Specifications for Electrical Installations and Supplements

Errata and Revisions

JULY 2020

for the Electric System Bulletin 750 Series

FIGURE 11: TYPICAL MANHOLE REQUIREMENTS

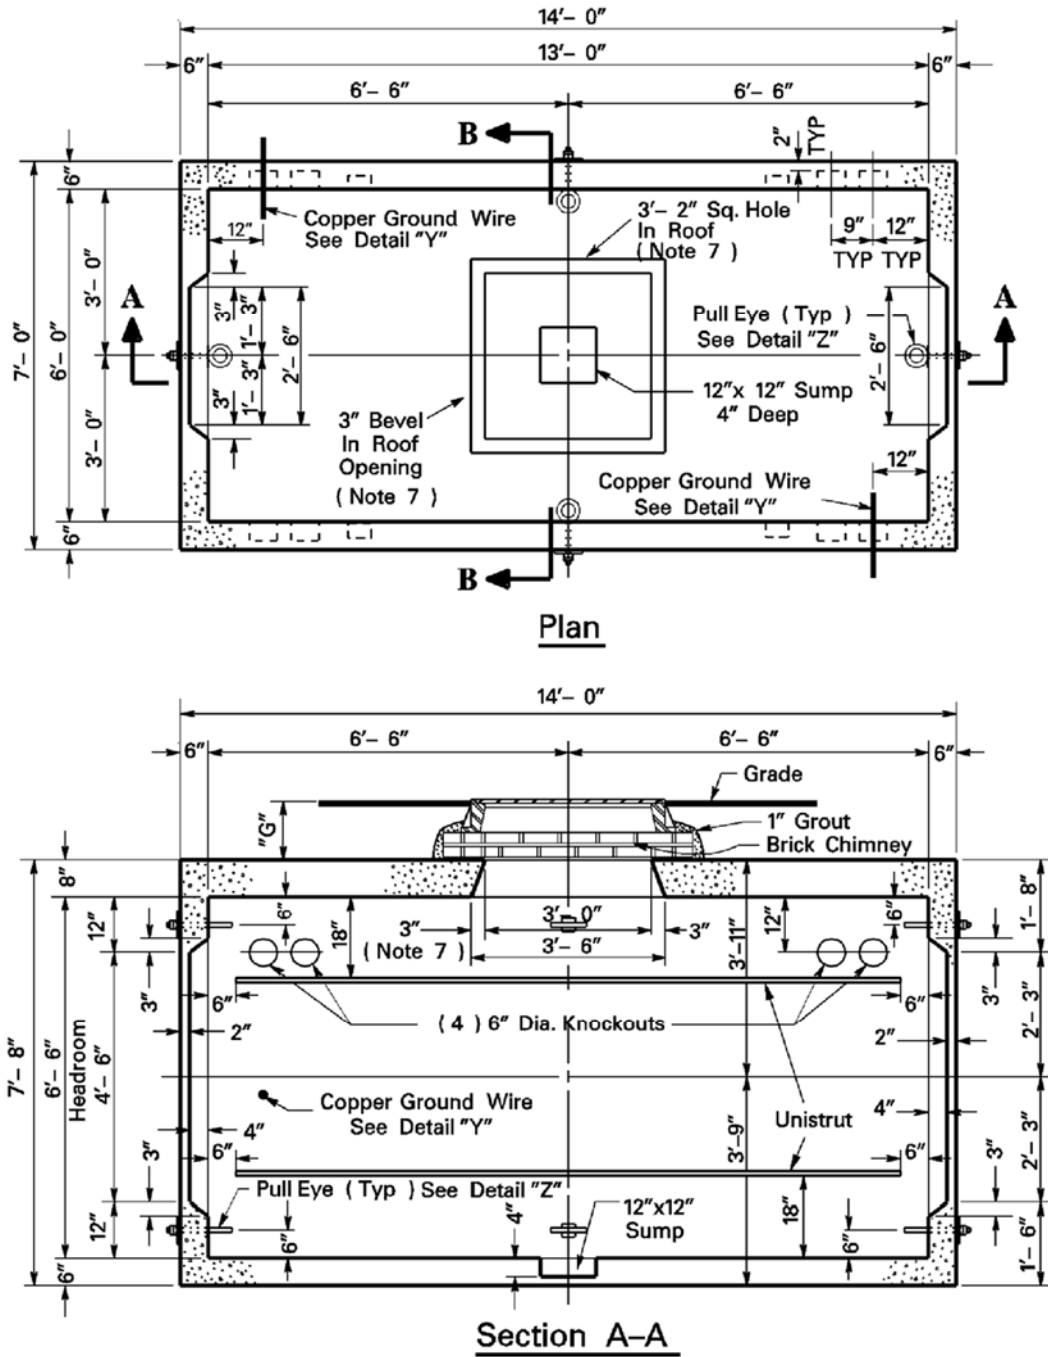
31	Figure 11	Sep-2010	Replace typical manhole requirements drawing with updated ground wire; see * below.
32	Figure 11 (cont'd)	Sep-2010	Replace typical manhole requirements continuation drawing with updated proper ground wire and detail Y; see * below.

Figure M-1 – Typical Primary Switchgear Metering Transformer Compartment Clearances

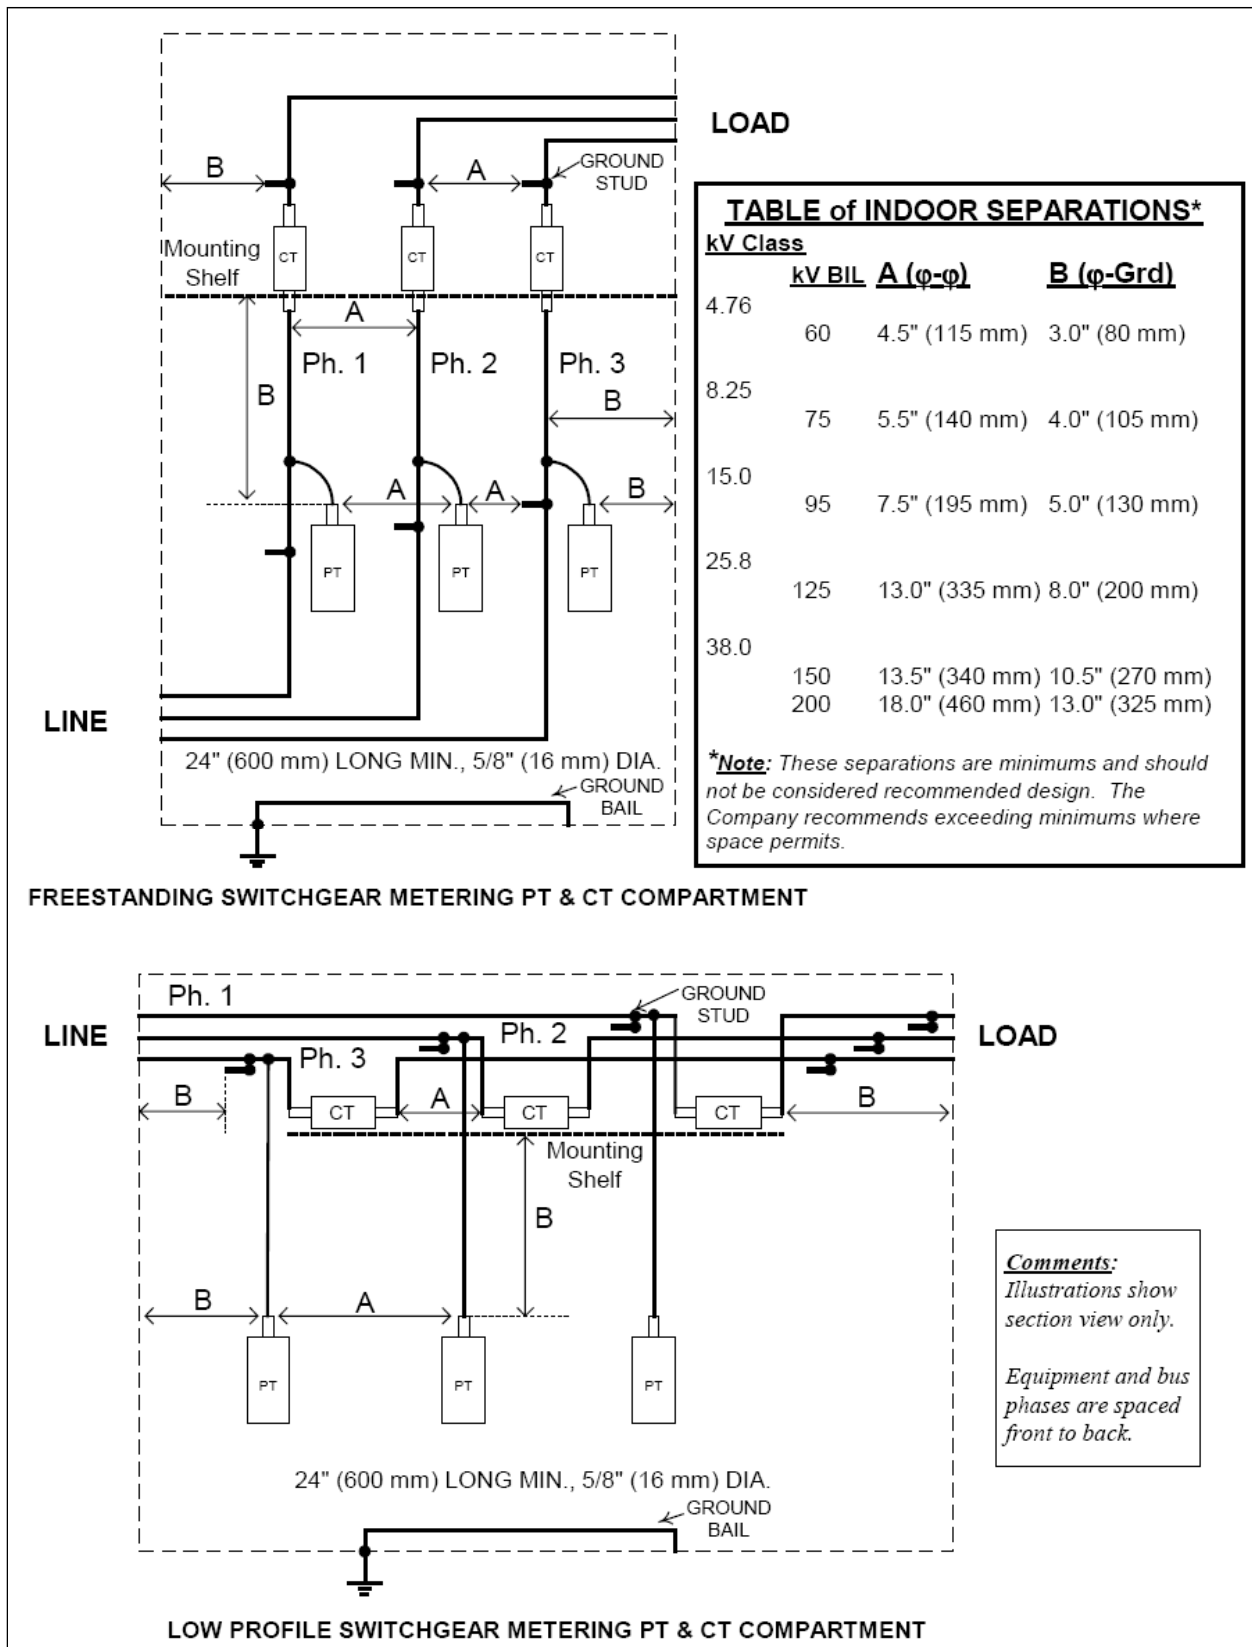
- d. The entire metering compartment shall be designed and constructed with adequate ventilation.
- e. The minimum width of the metering transformer compartment must be based on the electrical clearances of Figure M-1. The Customer shall maintain a minimum 10 ft. (3.0 m) unobstructed clearance in front of the metering transformer compartment access door.

- k. The metering transformer compartment shall be solely accessible by the Company. This requires section-to-section openings for through bus to be maintained as small as phase to ground clearances in Figure M-1 will allow.

- l. Where the clearances in Figure M-1 cannot be provided, Glastic (NEMA Type GPO 3 material) barriers are required between potential transformers and between potential transformers and the enclosure walls.

Figure M-1A – Typical Primary Switchgear Metering Transformer Compartments

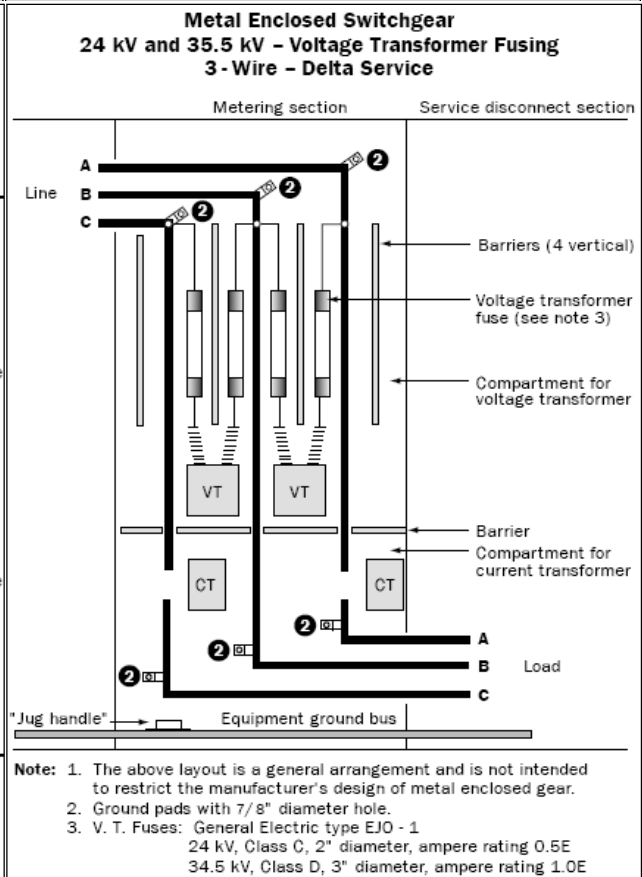
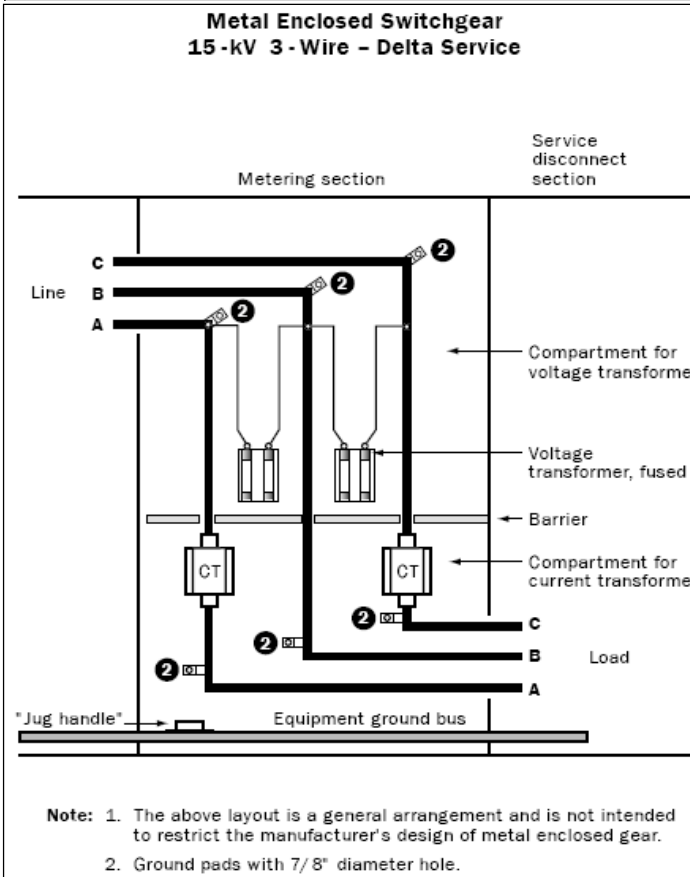
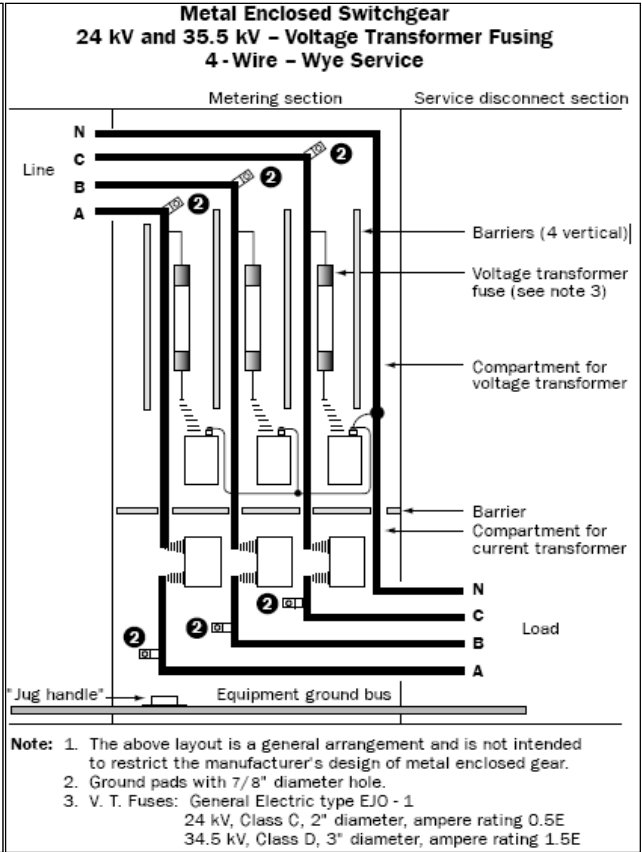
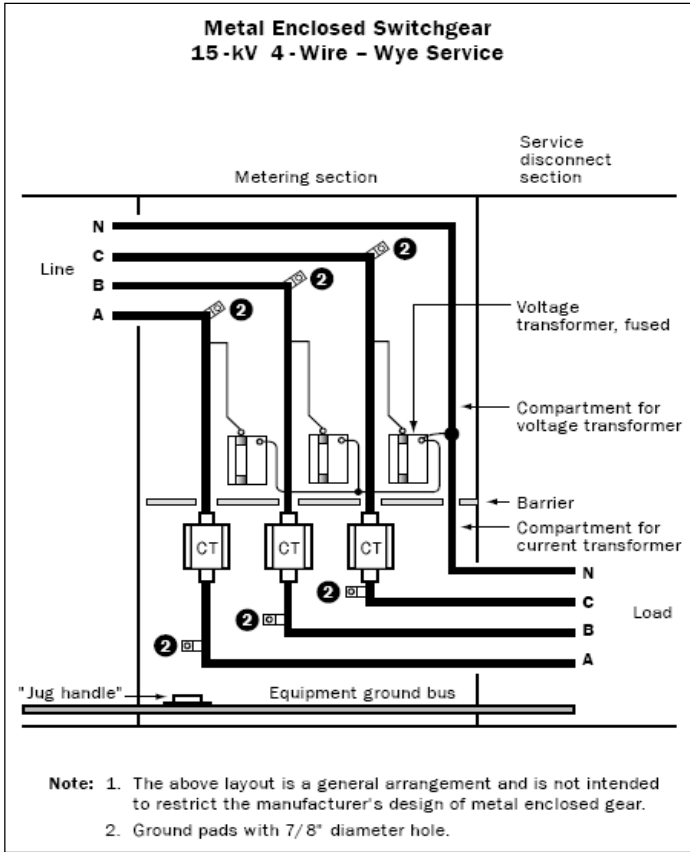
- p. A 5/8" (16 mm) dia. by 24" (600 mm) long copper ground bail shall be connected to the ground bus at both ends and located 7" (175 mm) behind the door and 5" (125 mm) above the door sill. In MA, NH, and RI, ground pads and "jug handles" shall be installed on the equipment ground bus as shown in Figure M-1A.

Figure 1A – Clear Area Requirements in Front of Line Termination and Metering Transformer Compartments for 15kV Class Primary Switchgear

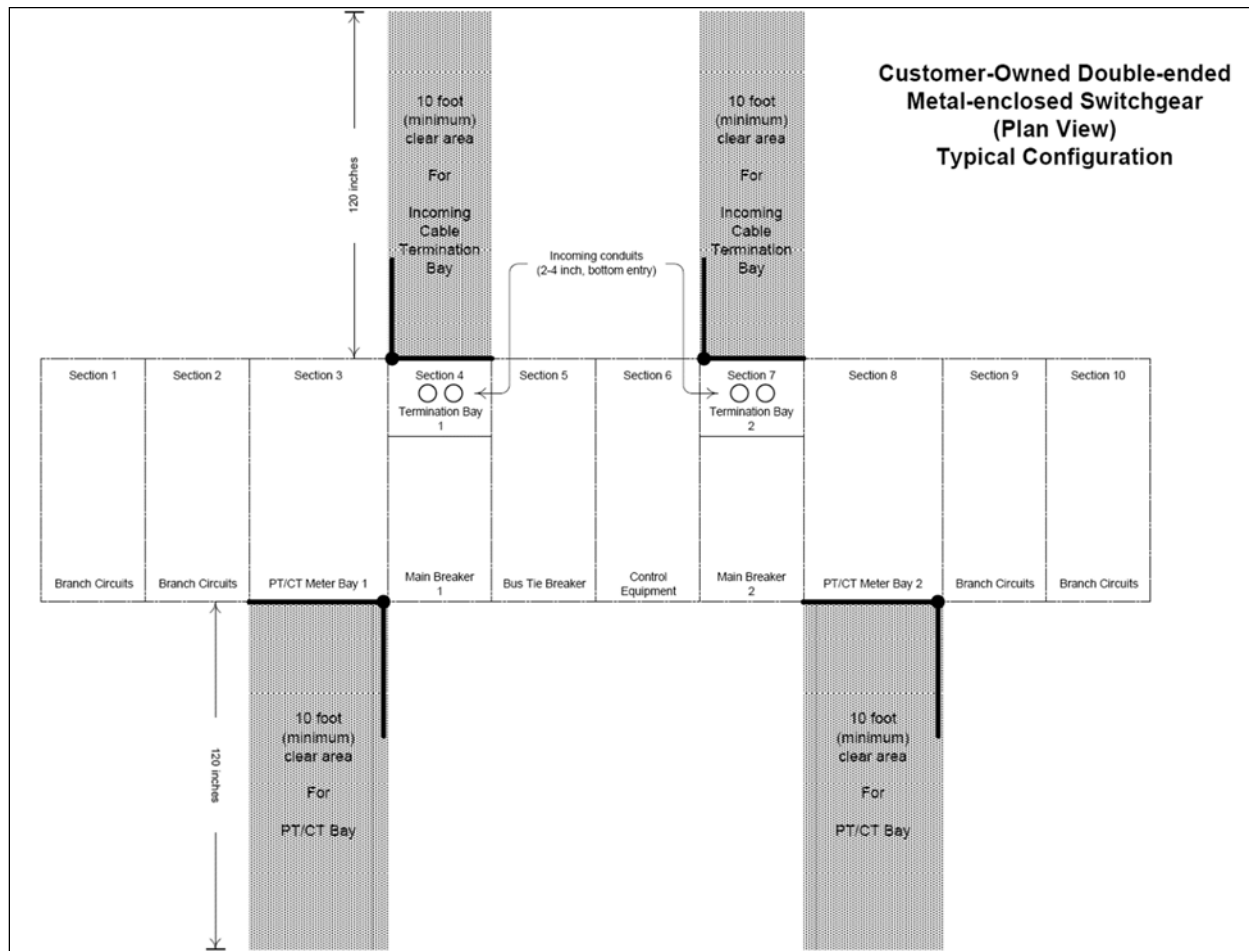
PAGE	SECTION	EFFECTIVE DATE	CHANGE
			Company's system by a main disconnecting switch. The switch shall be group operated causing separation by a clearly visible air gap. Where the Customer utilizes fuses as the overcurrent protection, the disconnecting switch shall be of loadbreak design. The switch or breaker compartment shall have provisions for dual locking of the door to allow access by either the Customer or the Company.
8 - 10	M	Sep-2010	Change this metering section in its entirety and replace it with the new information ** below.
Fig. 1	Note #3	Apr-2002	In Note 3, change "see Paragraph 18" to "see ESB 750 Section 4".
Fig. 1	Note #4 (new)	Sep-2010	Add new note: "Note #4: The clearances shown from the front of the service equipment to a building wall and from the rear of the service equipment to a building wall shall be both 10 foot (minimum) if the switchgear is designed with the Company required access to the incoming termination compartment on one side while the metering PT/CT compartment is on the other side; see Figure 1A. Otherwise, if the Company's access to both compartments is on the same side, then the other side's clearance can be reduced to the clearances presently shown." Add new Figure 1A ** below.
